ADDENDUM NO. 1

**JACKSON ELEMENTARY SCHOOL RENOVATIONS
Valparaiso, IN 46304**

This Addendum consists of page ADD 1-1 and attached Addendum No. 1 from Gibraltar Design dated November 9, 2022 and consisting of 4 pages and 29 drawings.

Addendum One (AD.01) to the drawings and specifications prepared by Gibraltar Design for **Jackson Elementary School Renovations** for Duneland School Corporation, Chesterton, Indiana.

© GIBRALTAR DESIGN
SHEET
A-401

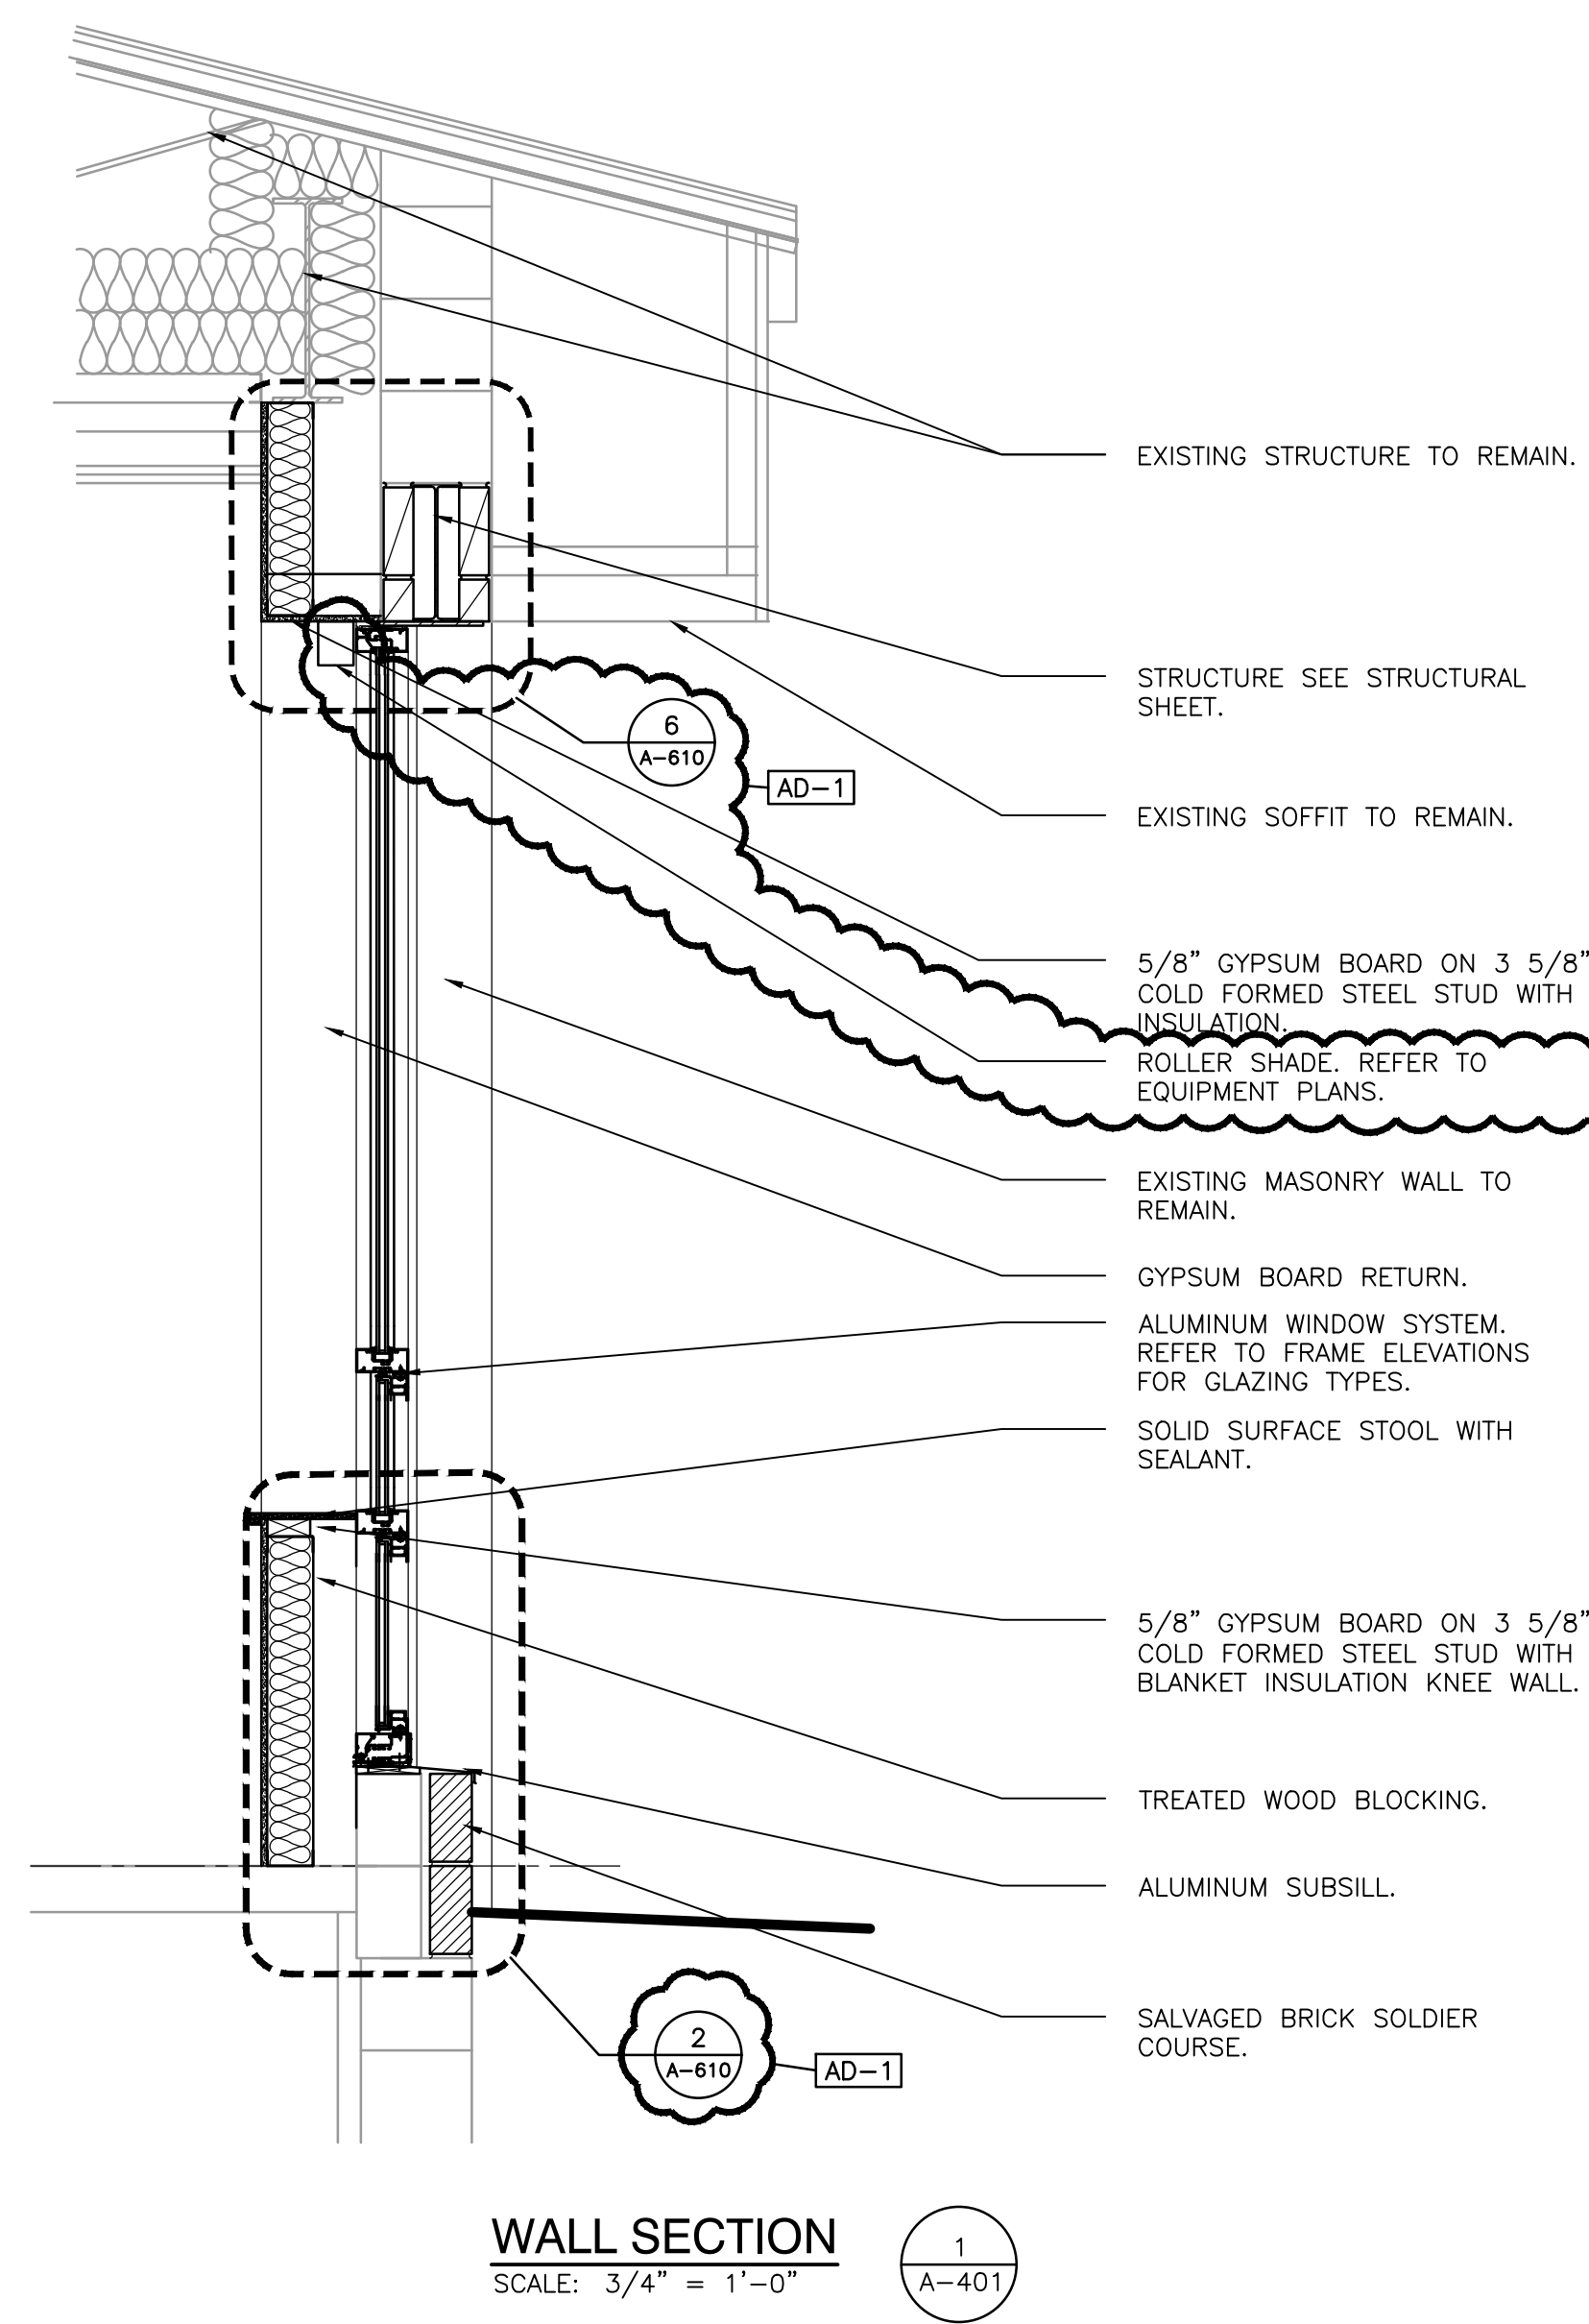
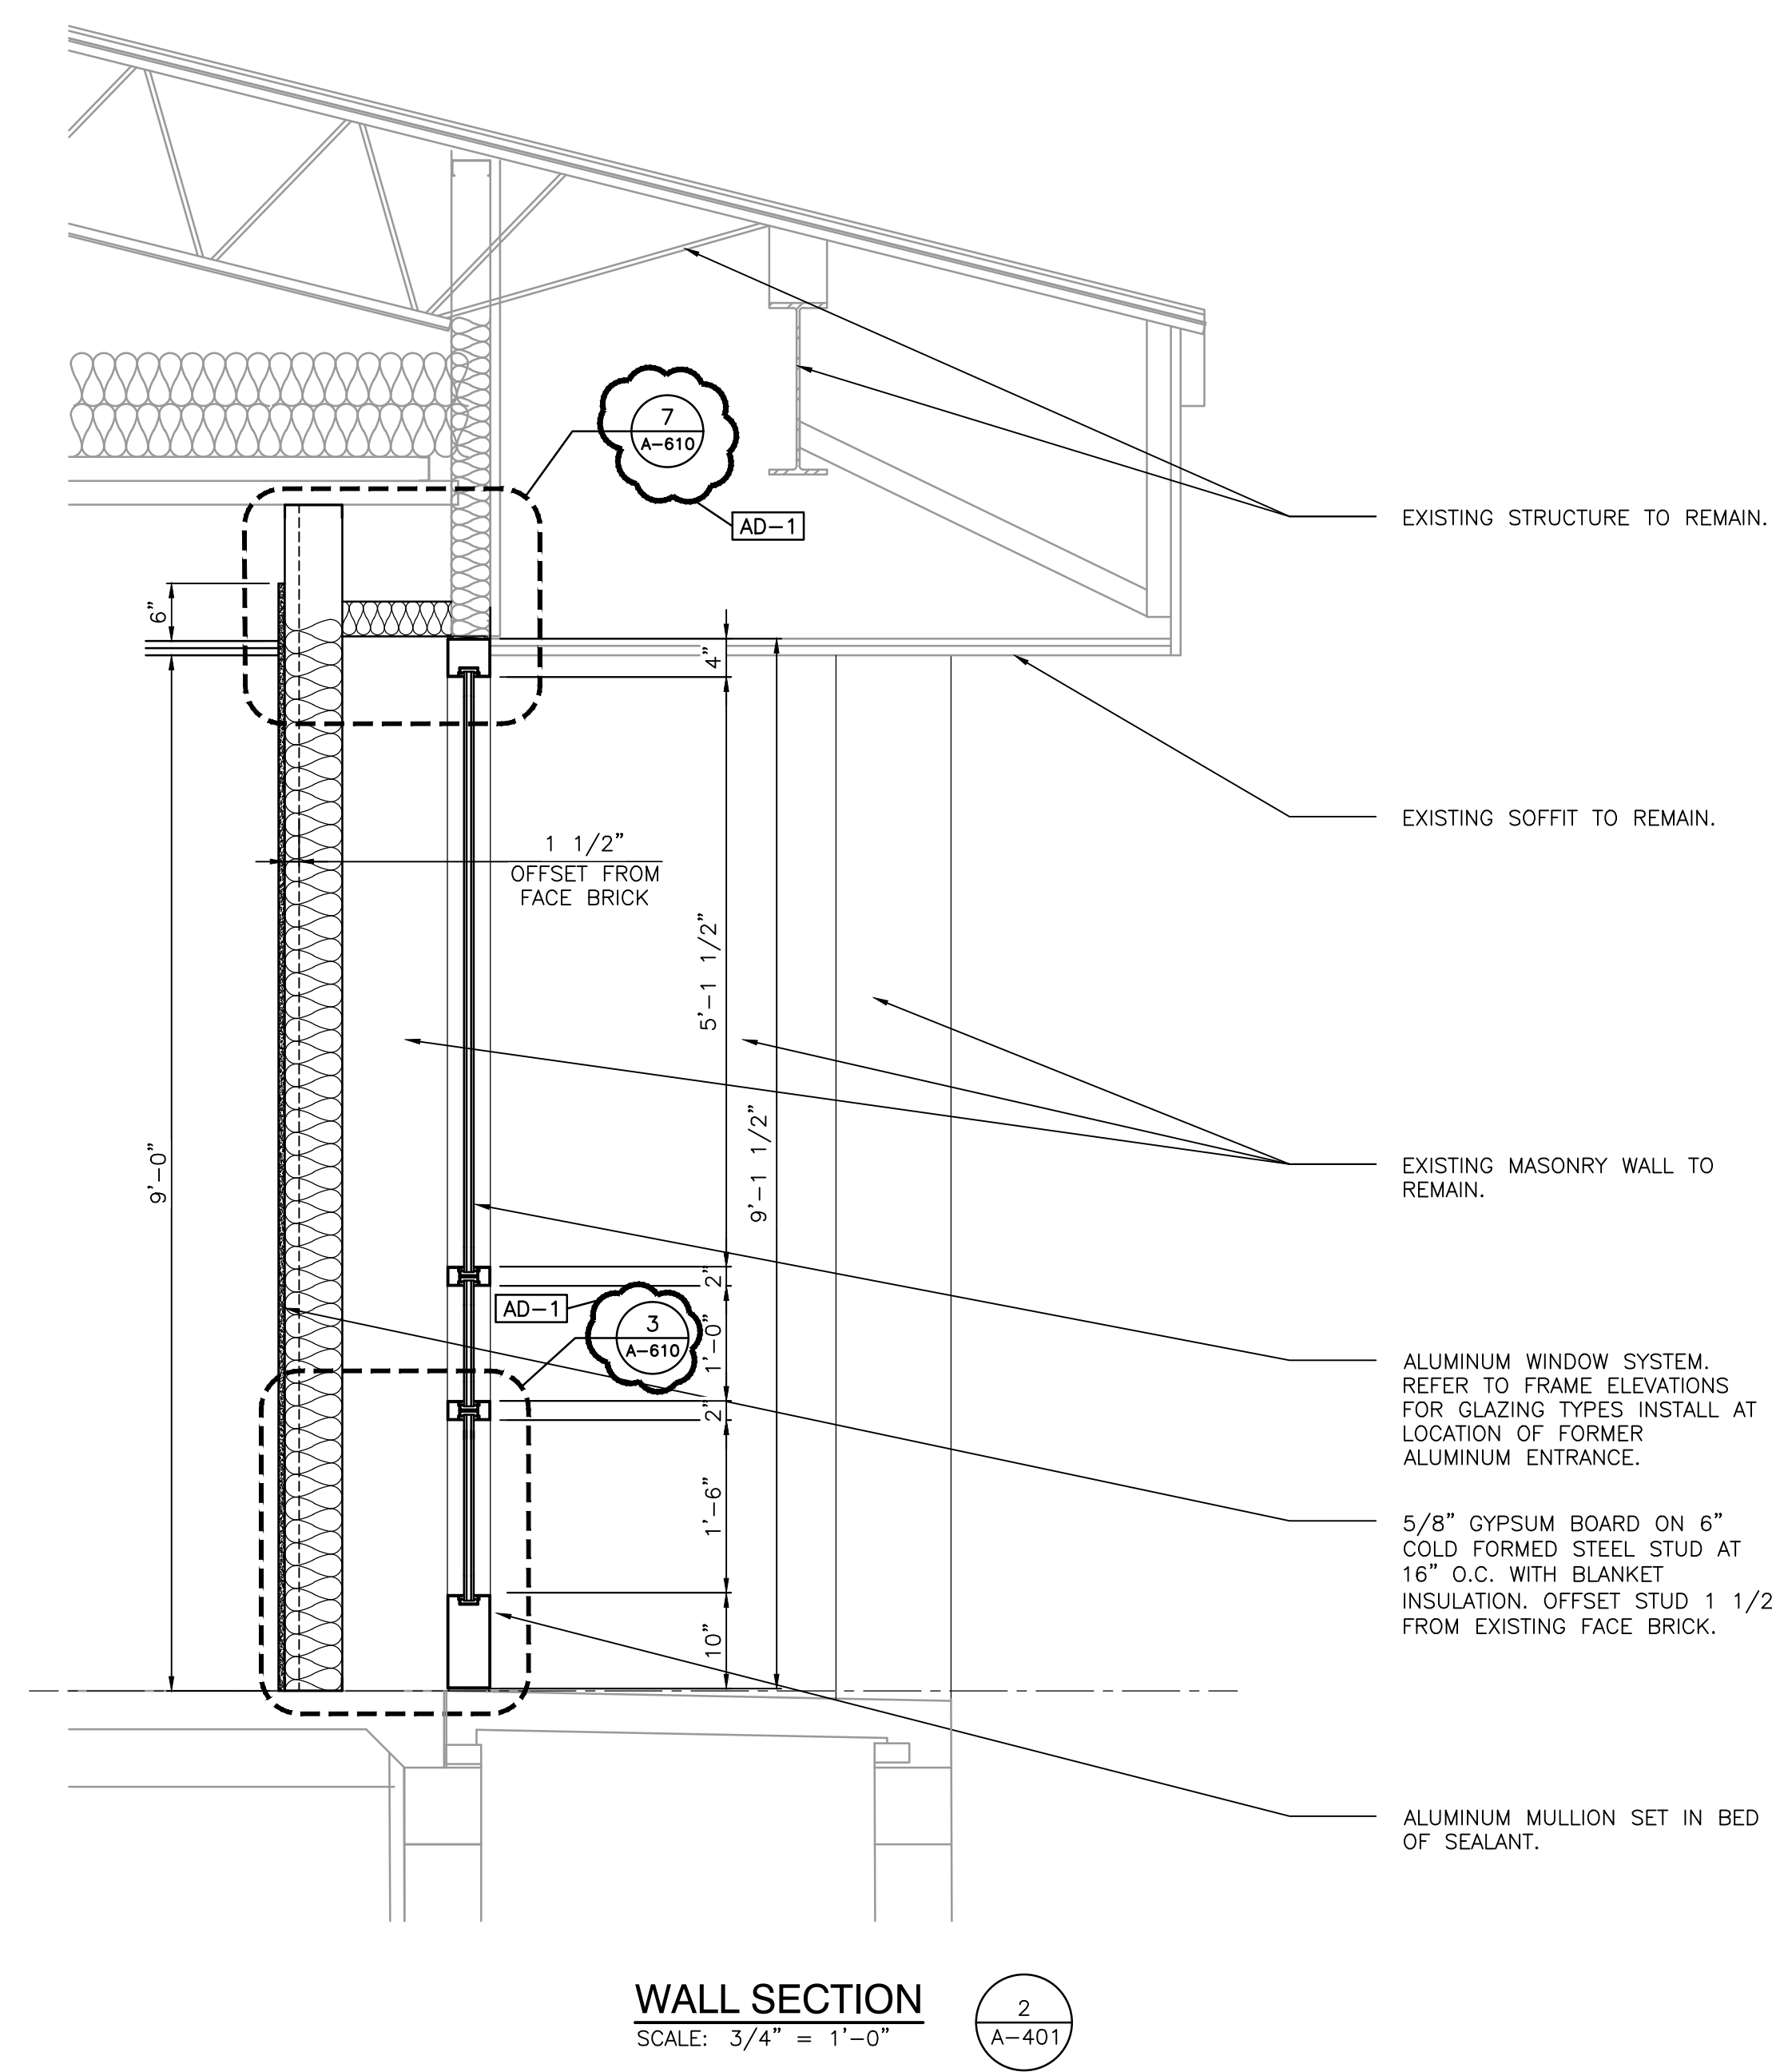
4. Sheets A-401

- A. Refer to revised full size drawing, included in this Addendum, for the following revisions:
 - 1. Updated detail bubble numbers.

A-701

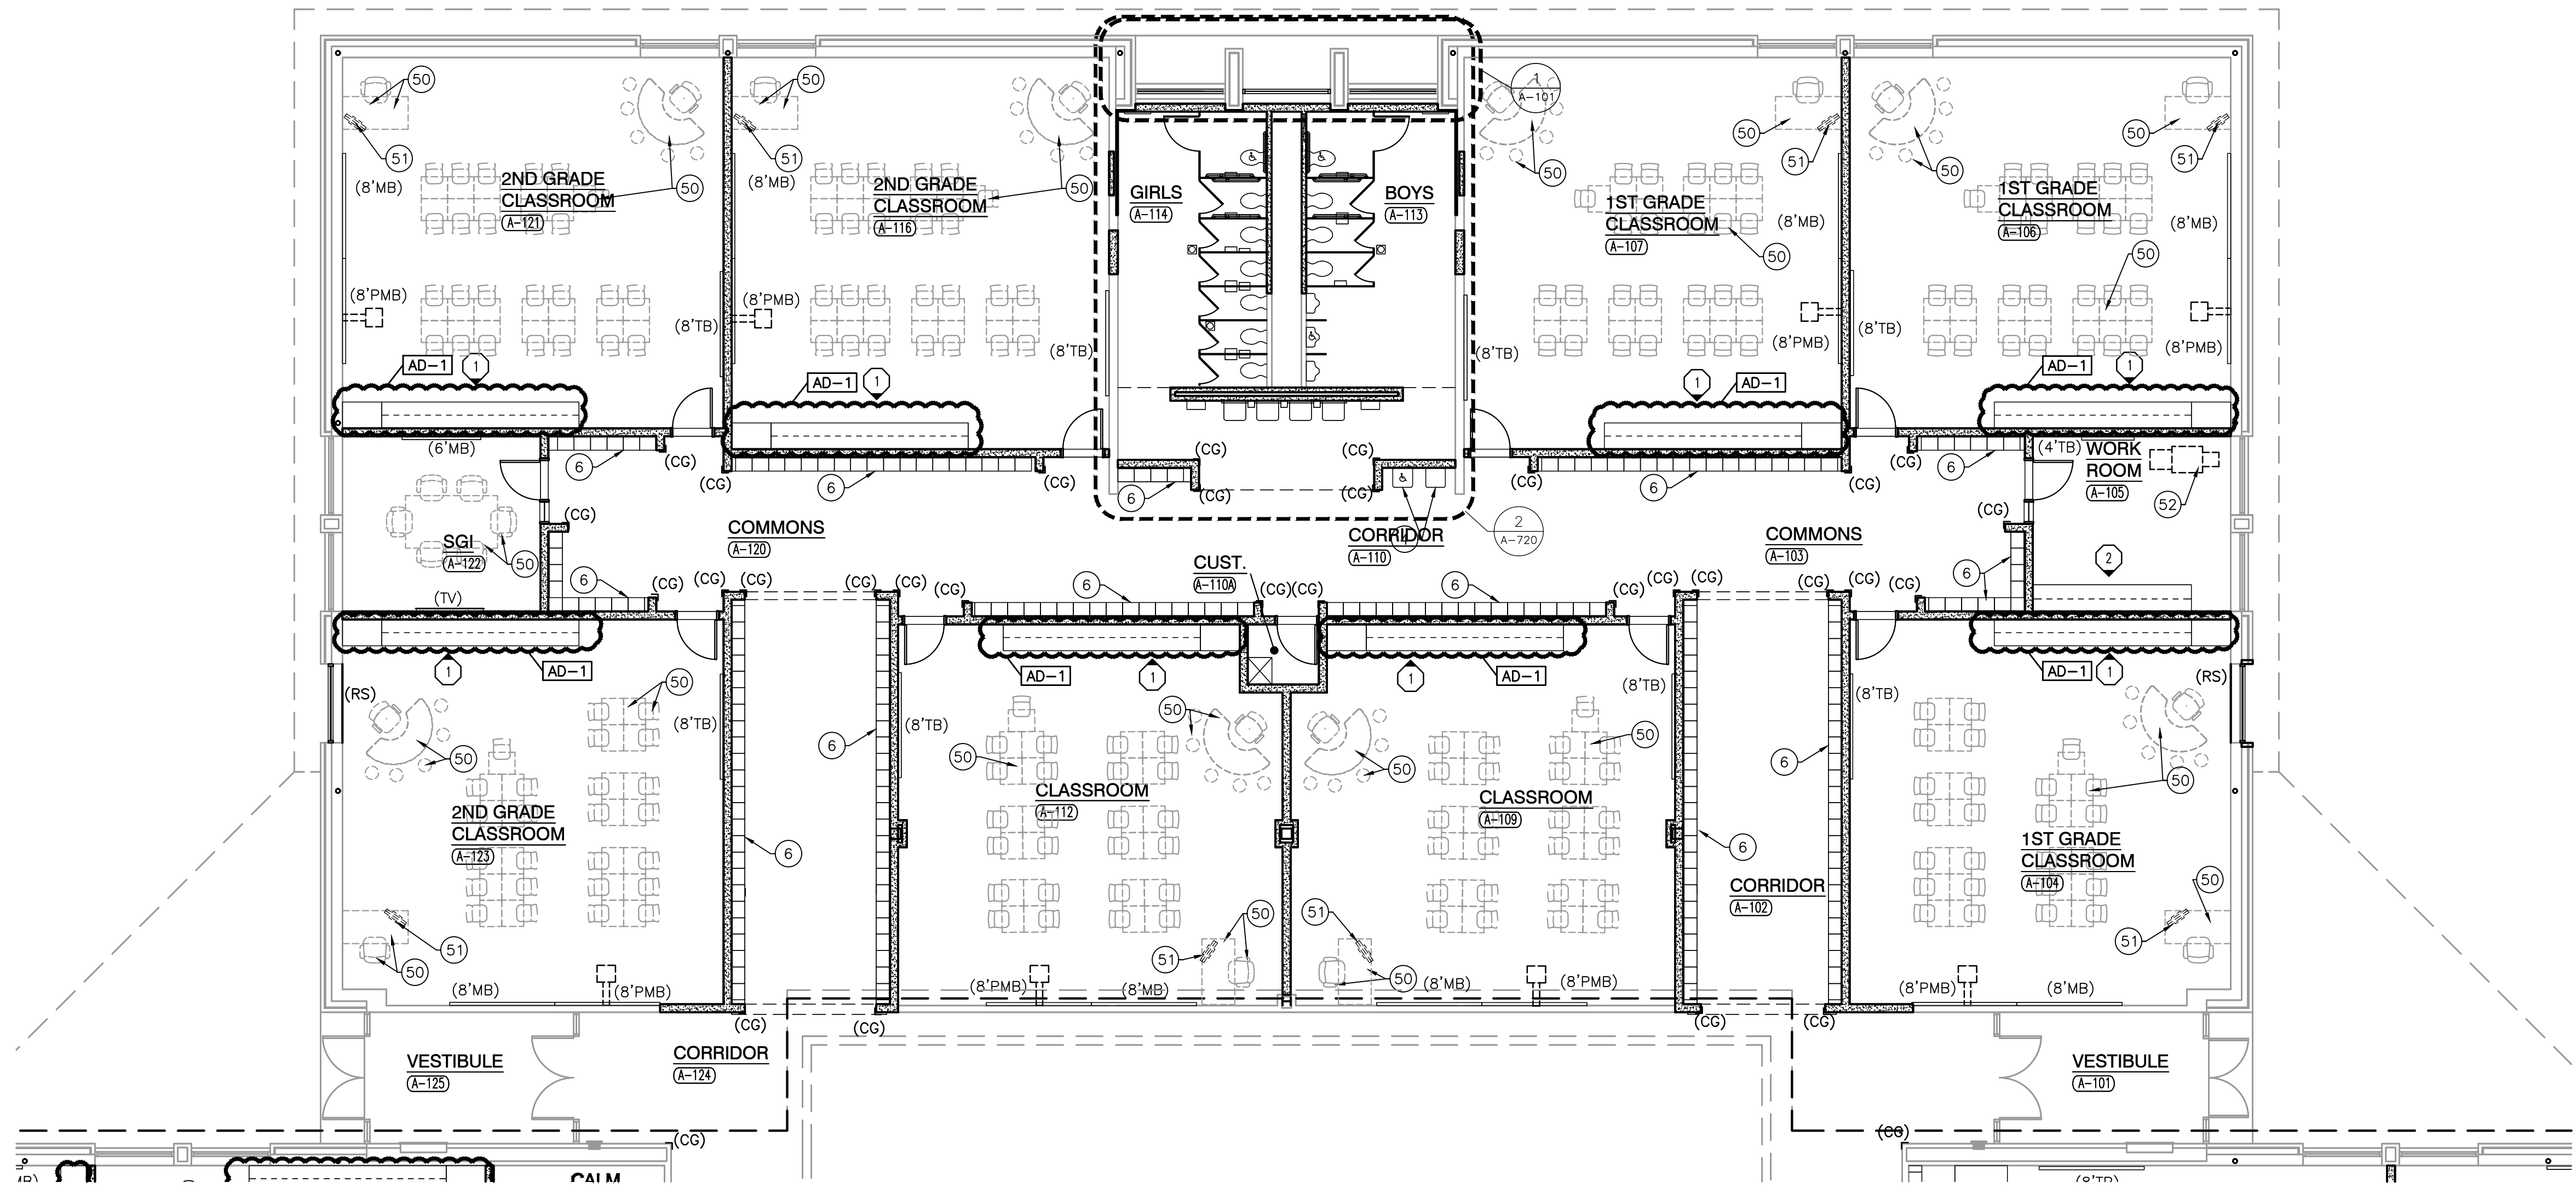
5. Sheet A-701

- A. Refer to revised full size drawing, included in this Addendum, for the following revisions:
 - 1. Plan casework length change in classrooms.
 - 2. Note added detail number for roller shades.
